**RFP# 4237 - Addendum #1  
Roof Replacement  
Caudle Park Elementary**

# CAUDLE PARK SCHOOL ROOF REPLACEMENT

35 MCGEE DRIVE  
LOWER SACKVILLE, NS B4C 2J1  
ISSUED FOR ADDENDUM 01

**1 ROOF PLAN**  
A-101 SCALE: 1/8" = 1'-0"

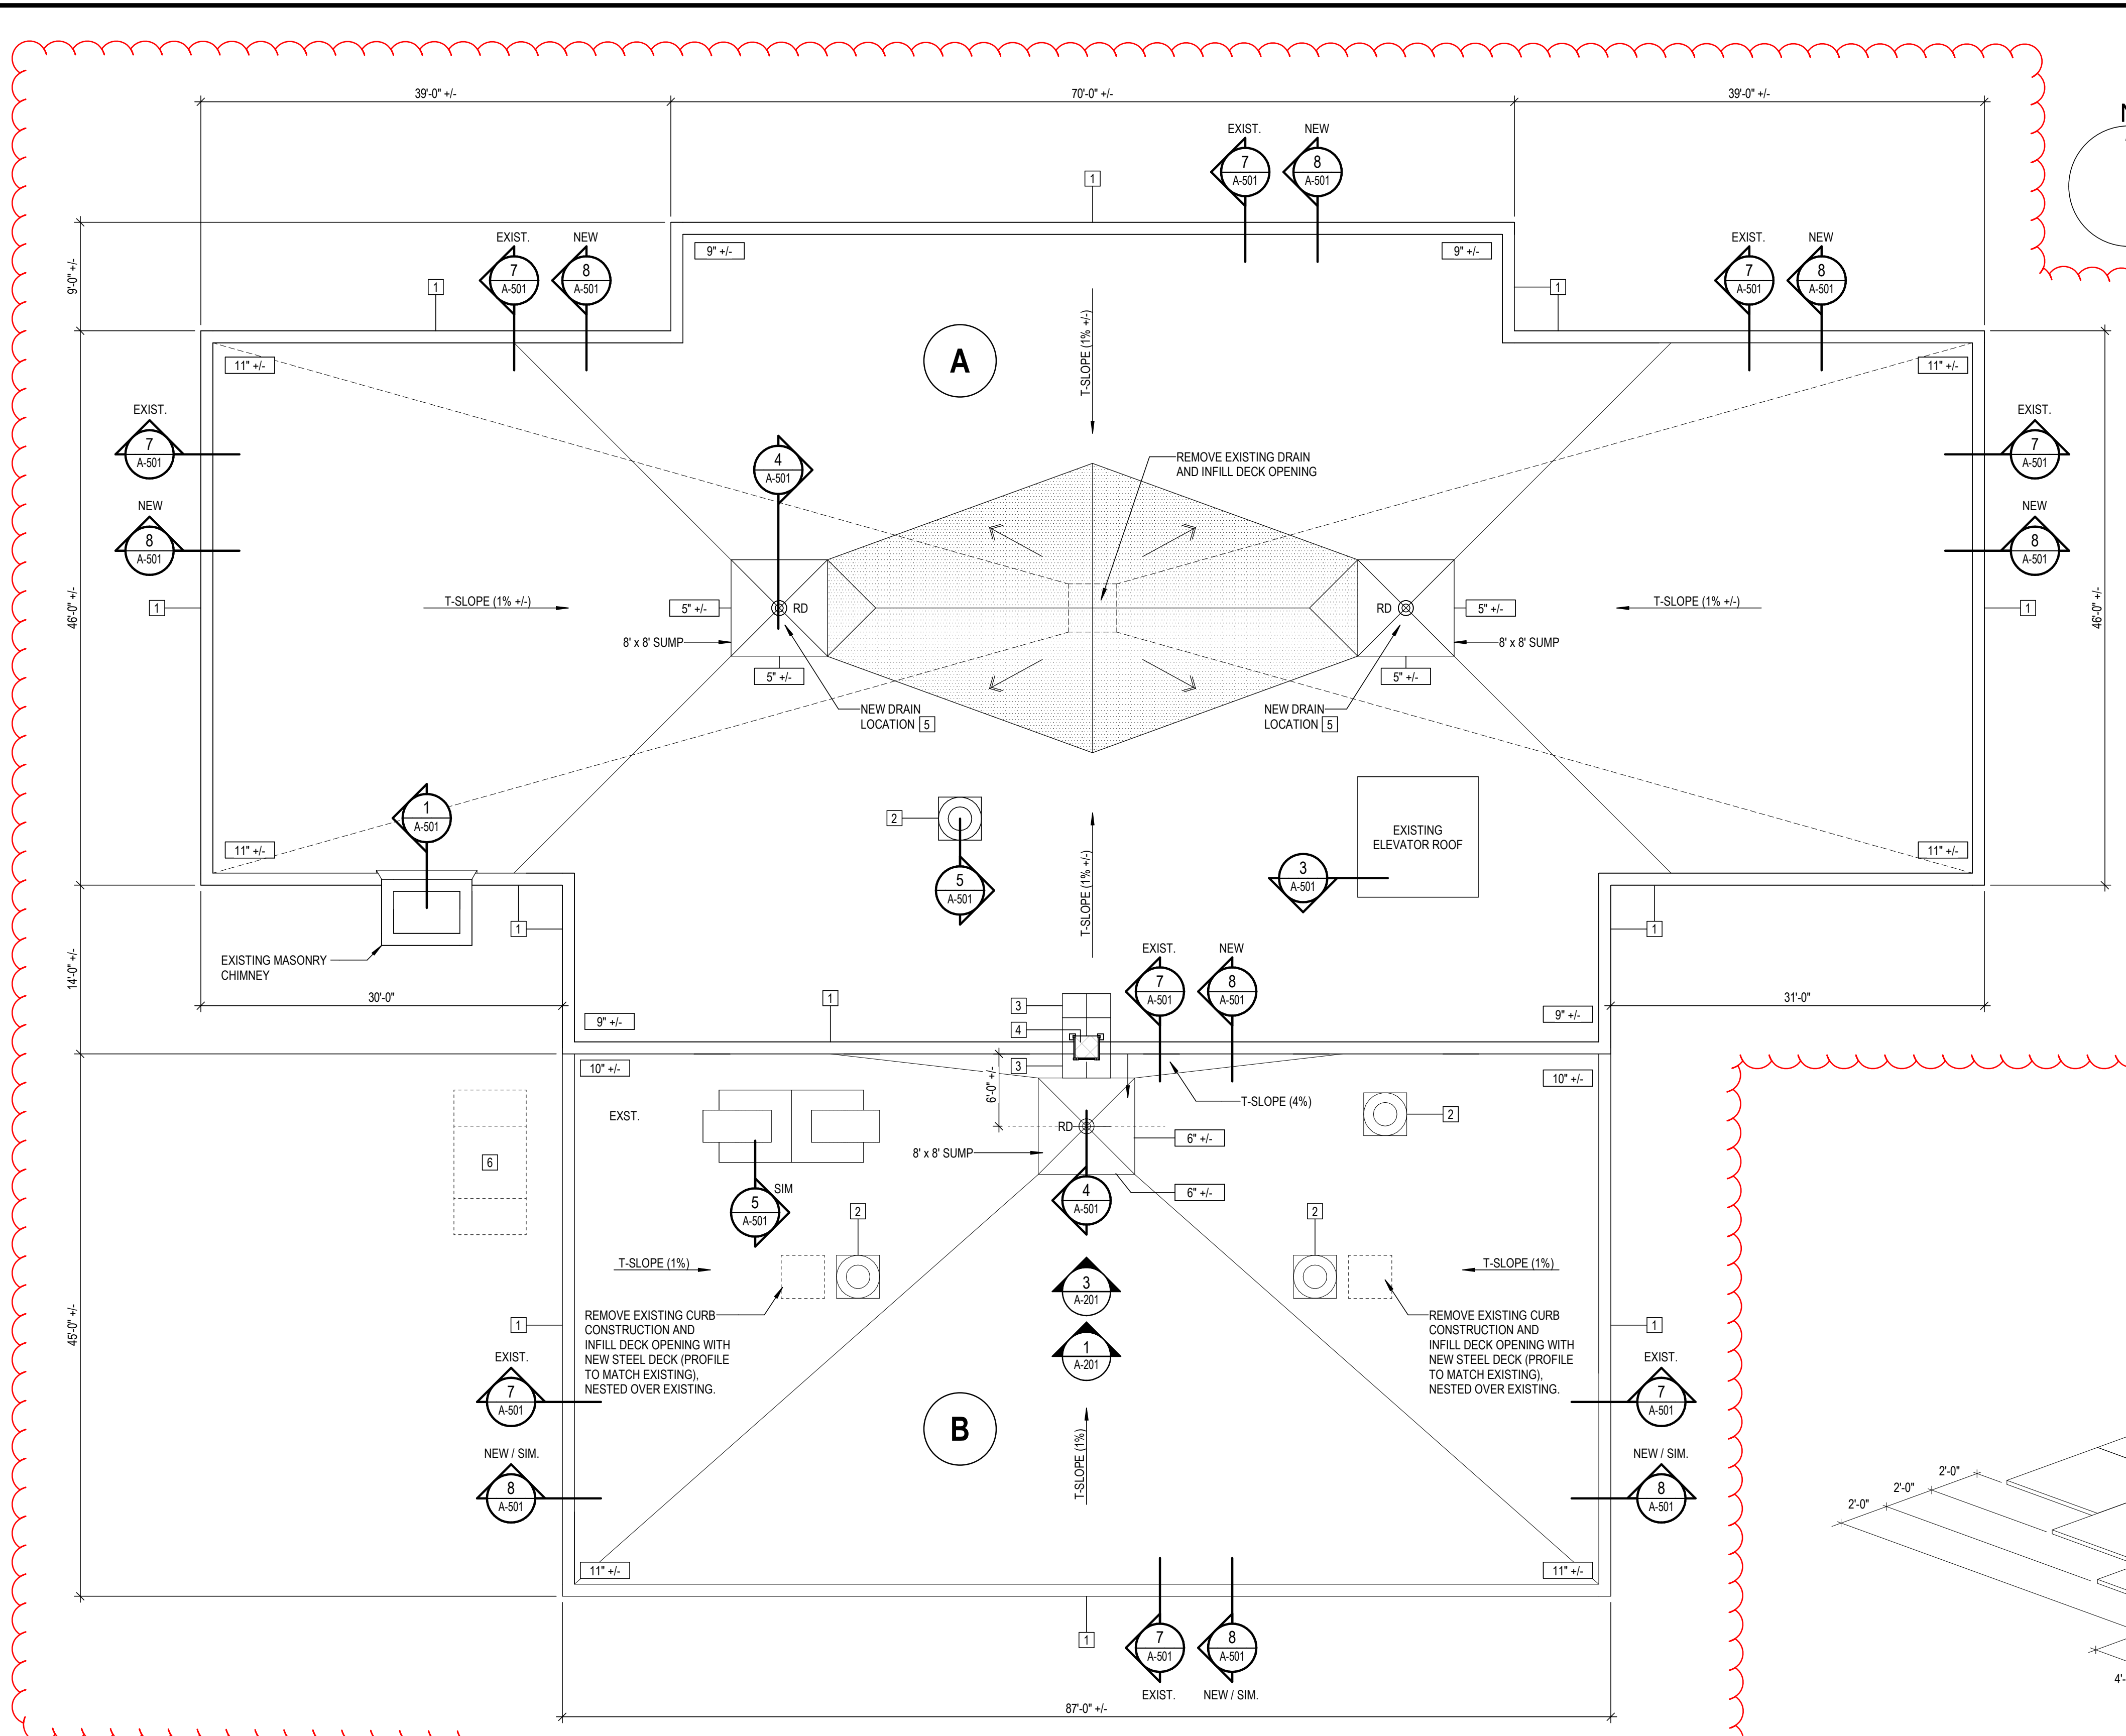
1. Add Specification Section **05 52 25 – Metal Ladders.**
2. **Reference Drawing: A-101, Roof Plan:**
  - .1 Detail 1, Roof Plan:
    - .1 Revise drain layout/locations at Roof A, as indicated.

- .2 Revise drain layout/locations at Roof B, as indicated.
  - .2 Keynote Legend:
    - .1 Revise note 4, as indicated.
  - .3 Add note H to GENERAL NOTES, as follows:

ALL EXISTING ROOF DRAINS ARE TO BE REPLACED WITH NEW DRAINS. VERIFY EXACT LOCATION OF DRAINS BY THE CONTRACTOR. TWO (2) NEW DRAIN LOCATIONS ARE TO BE ADDED AT ROOF A. INSTALLATION OF ADDITIONAL DRAIN PIPING IS BY HRCE. SUPPLY AND INSTALLATION OF DRAIN IS BY THE CONTRACTOR (REFER TO KEYNOTE #5). VERIFY EXACT LOCATION OF DRAIN PRIOR TO PREPARING TAPERED INSULATION SHOP DRAWING.

**1 SOUTH ELEVATION**  
A-201 SCALE: 1/4" = 1'-0"

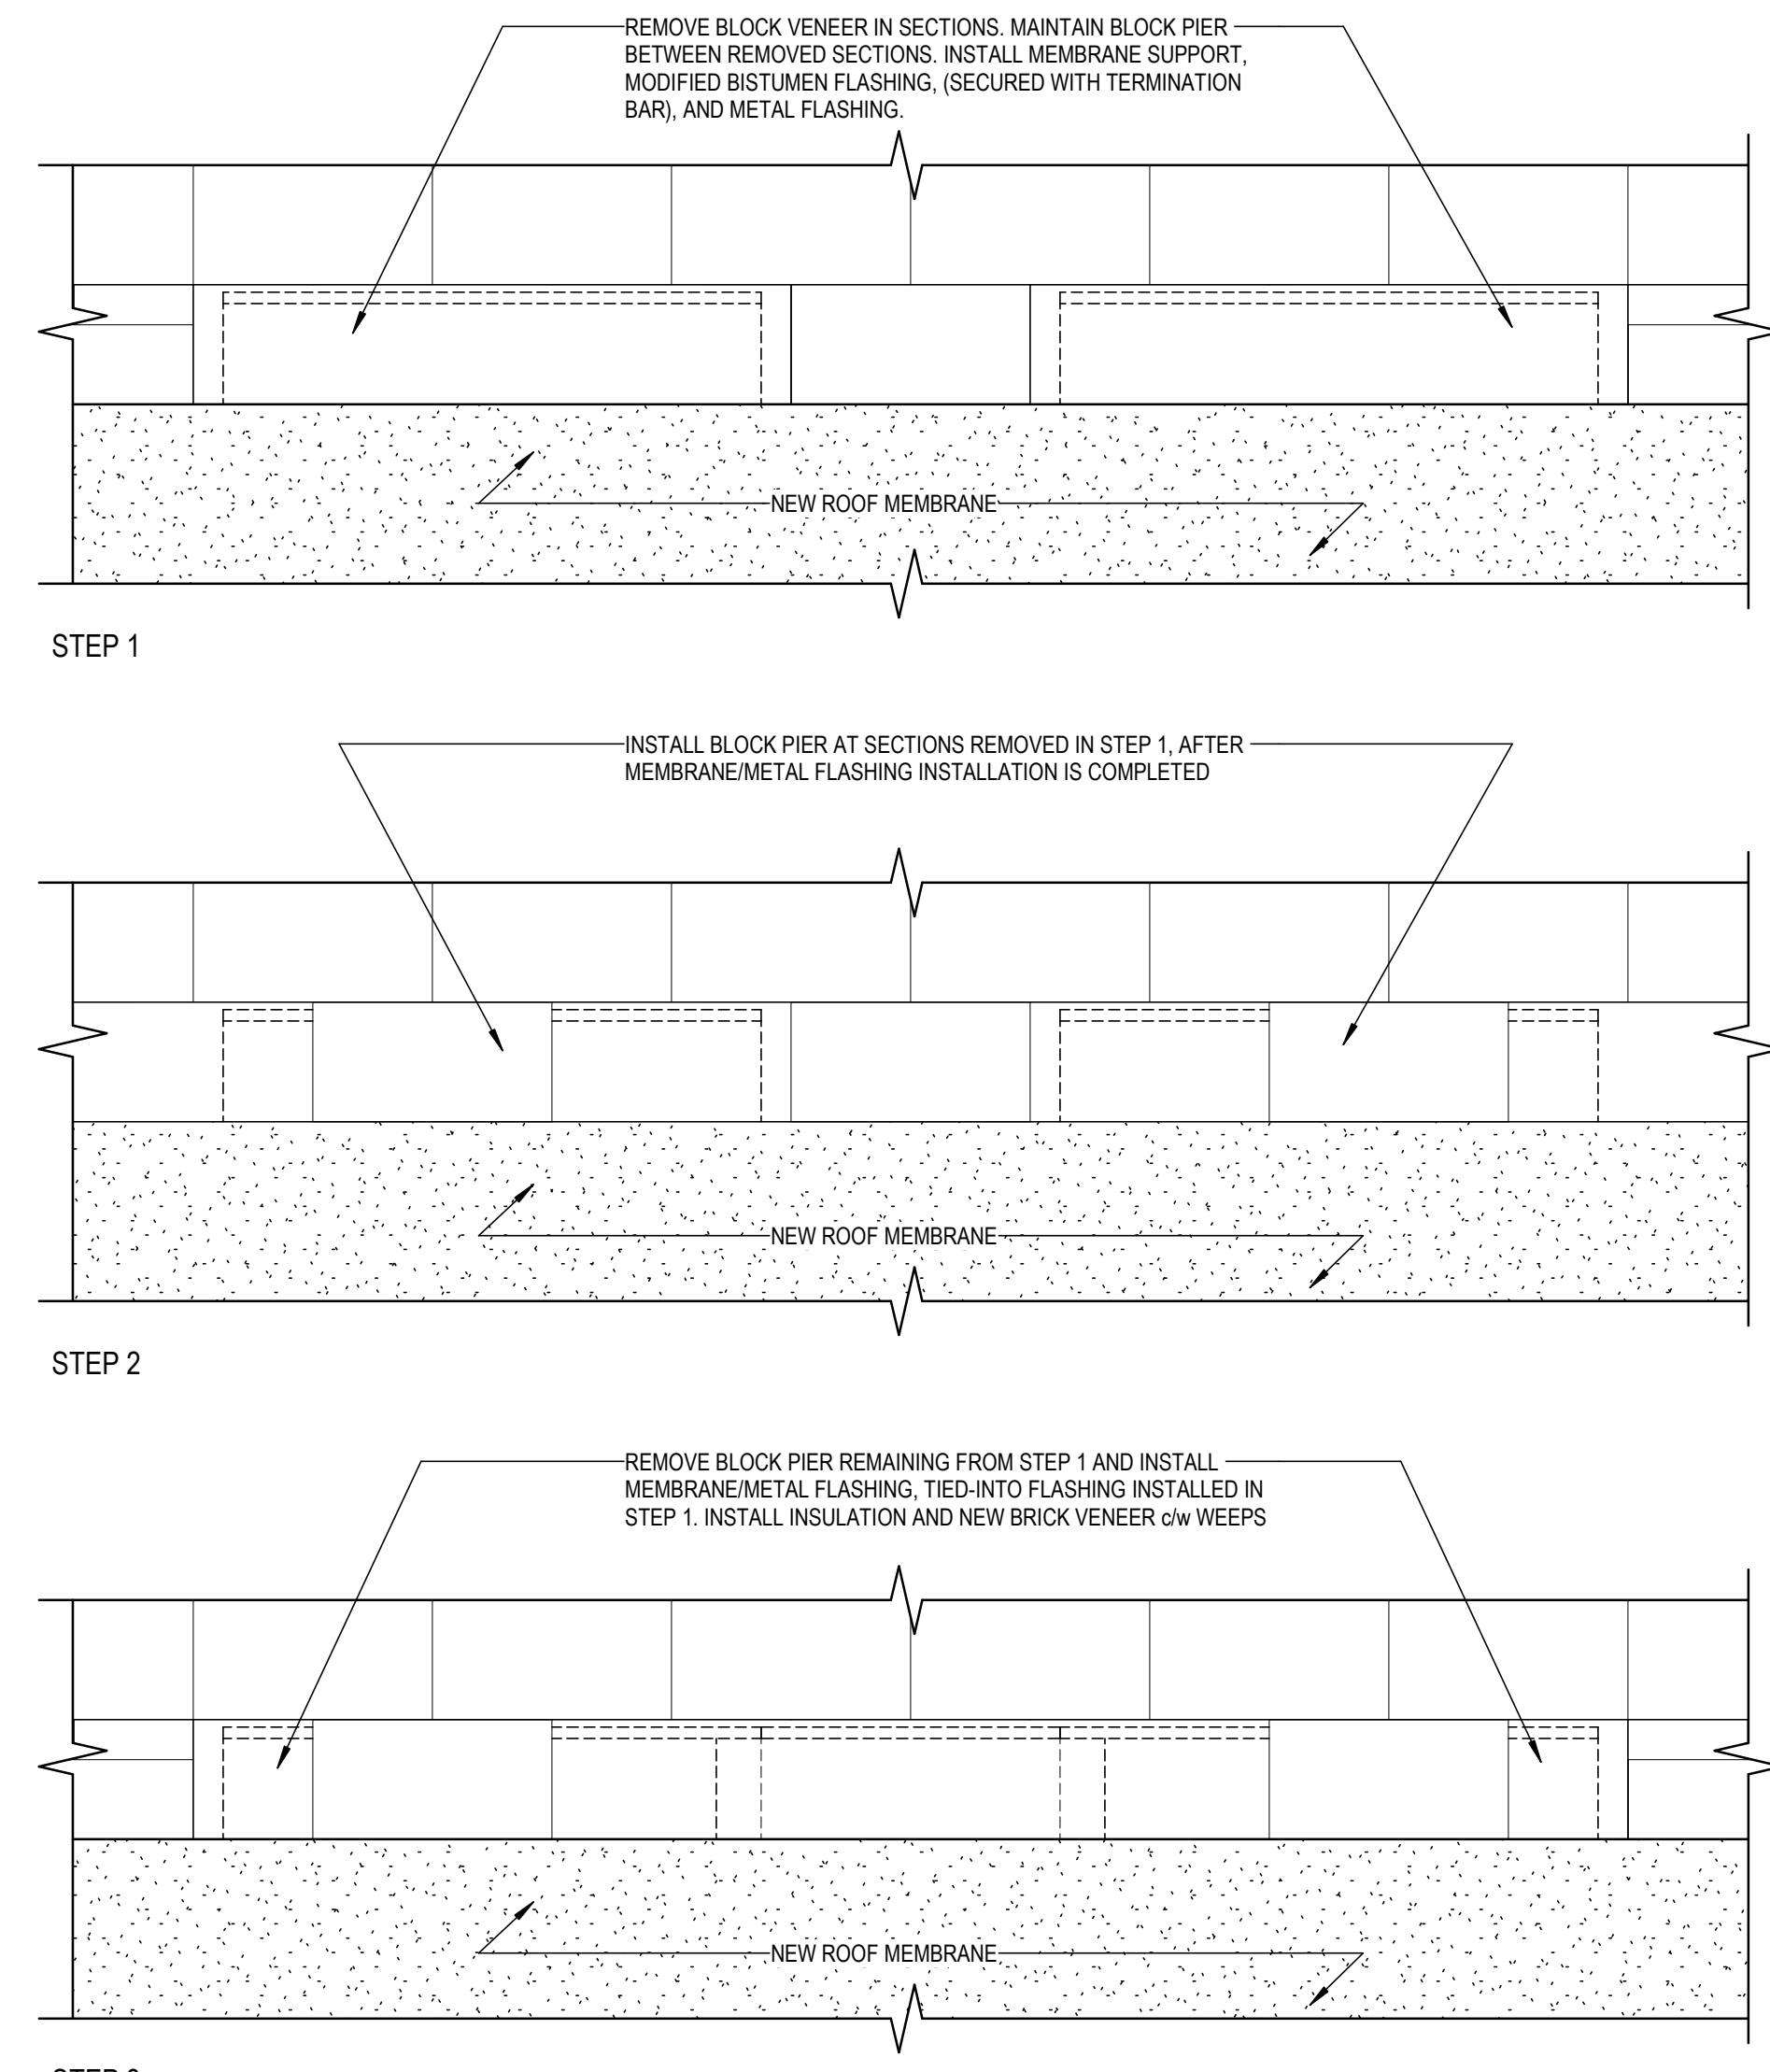
- .1 Detail 1, South Elevation:
    - .1 Revise notes and wall height, as indicated.
  - .2 Add Detail 3, Roof Ladder Elevation.
  - .3 Add Detail 4, Roof Ladder Section.

**6 PARAPET AT ROOF A (EXISTING)**  
 A-501 SCALE: 3" = 1'-0"

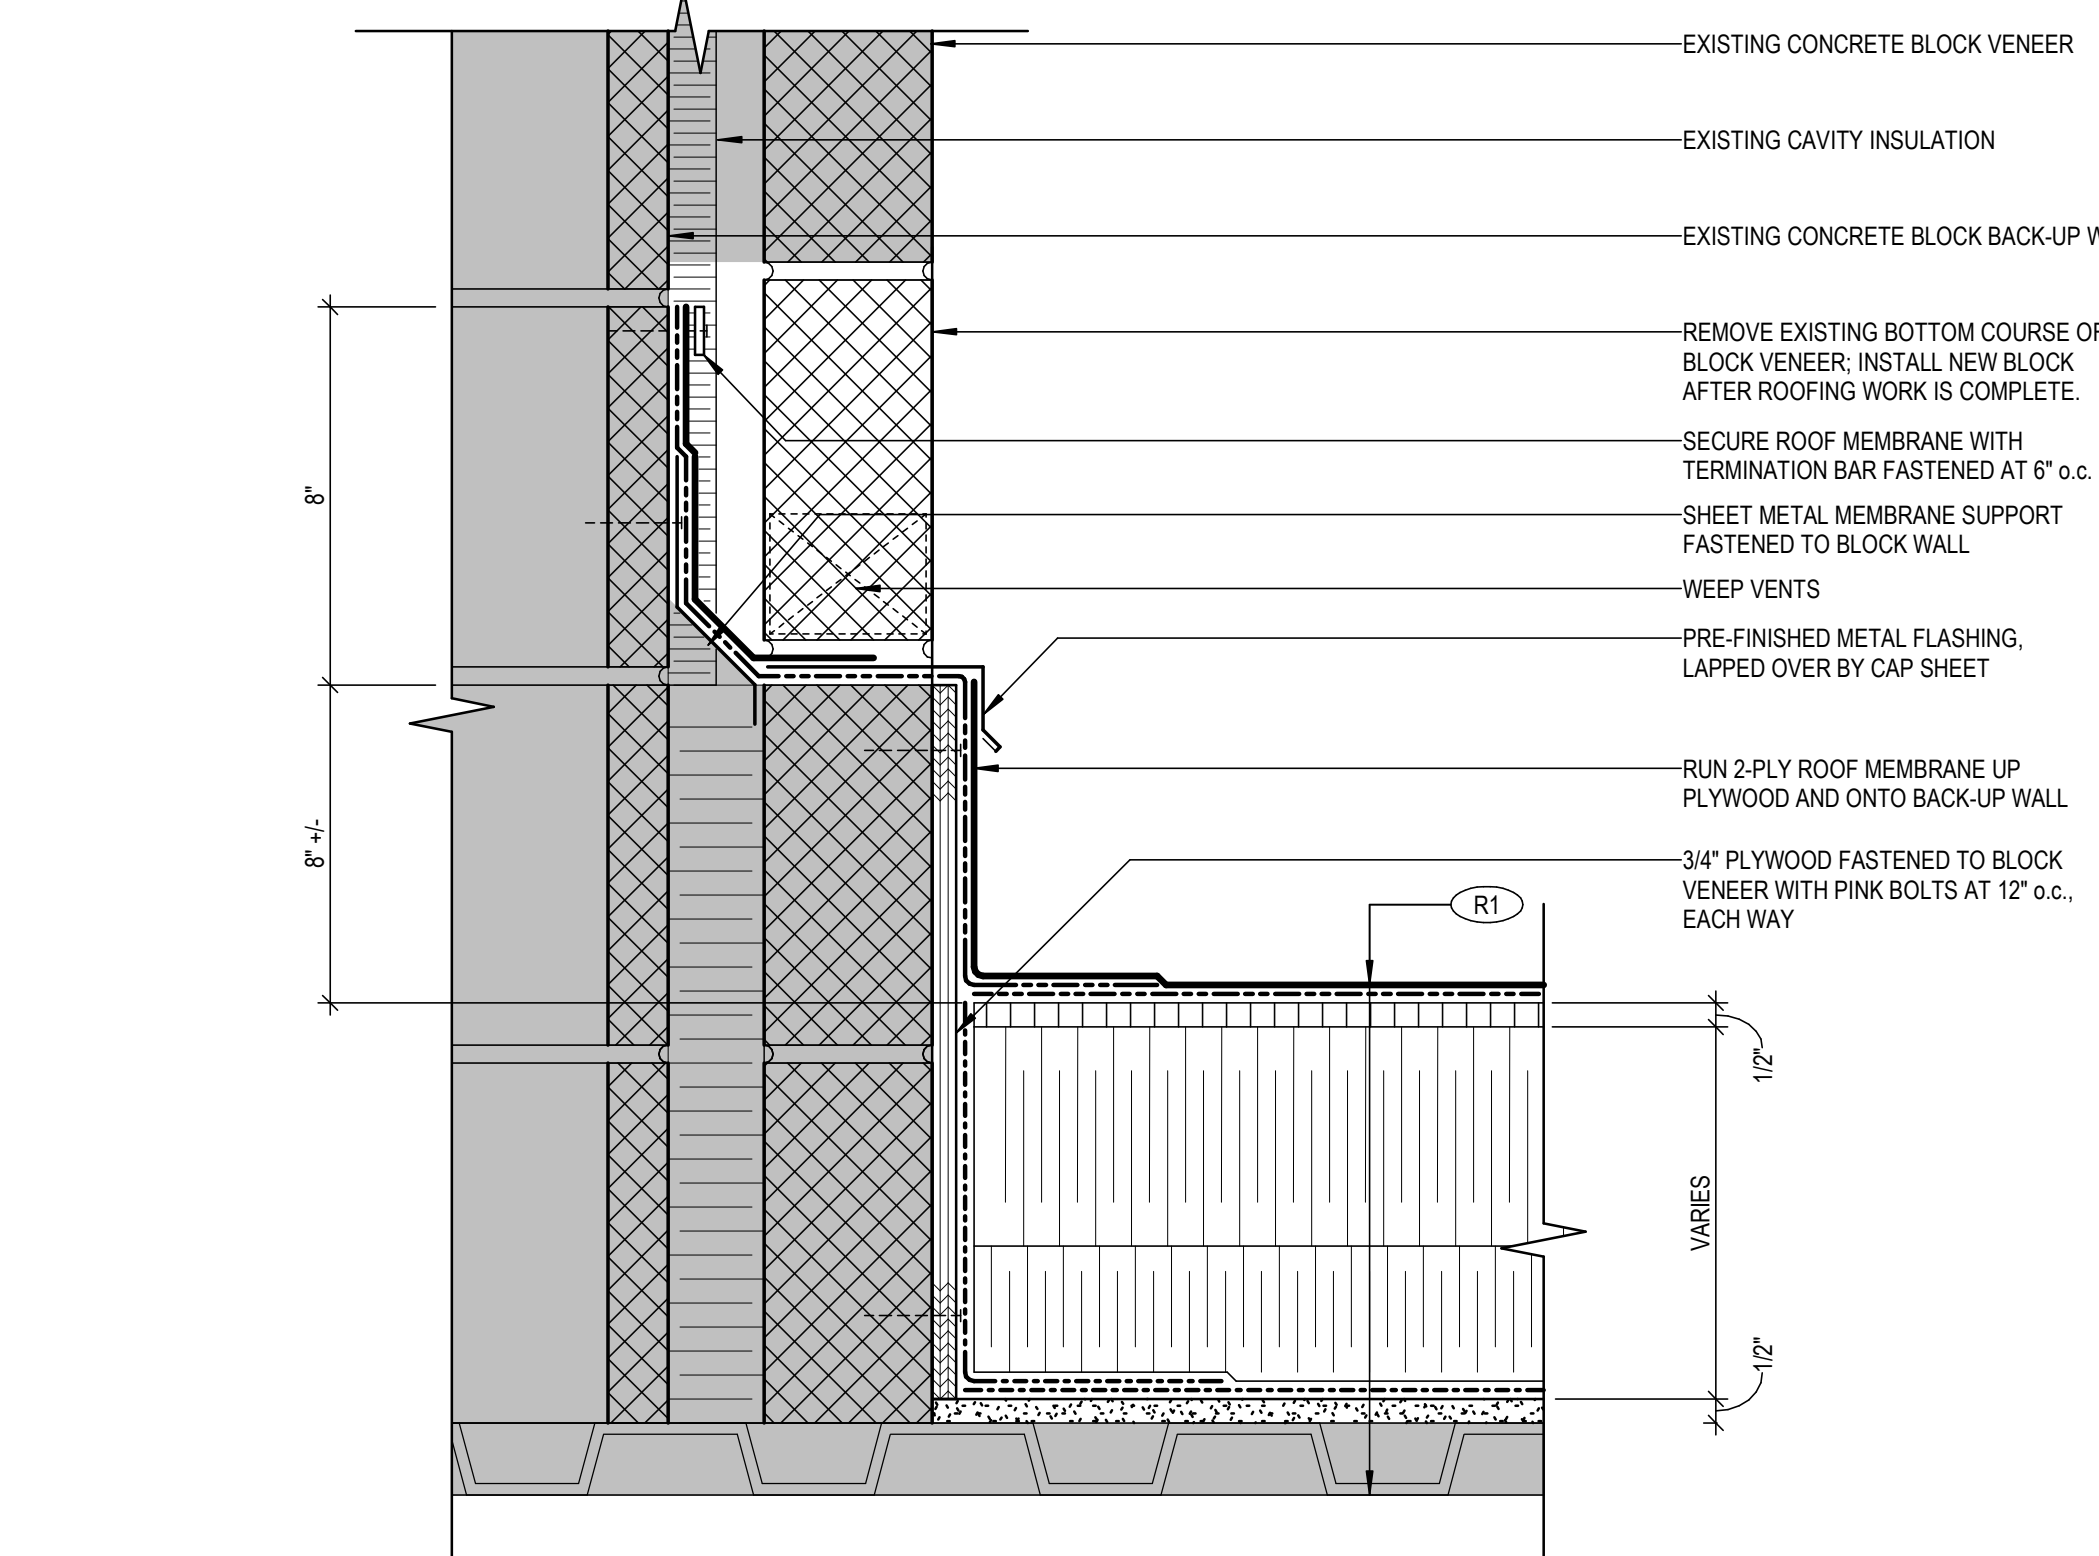
- .1 Delete Detail 5, 'Roof Drain at Sloped Structure at Roof A'.
- .2 Re-number details, as indicated.
- .3 Detail 6, Parapet (Existing):
  - .1 Rename to read 'Parapet at Roof A' and revise as indicated.
- .4 Detail 7, Parapet at Roof B (New):
  - .1 Delete detail and replace with 'Parapet at Roof B (Existing)'.
- .5 Detail 8, Parapet at Roof A (New):
  - .1 Revise as indicated.
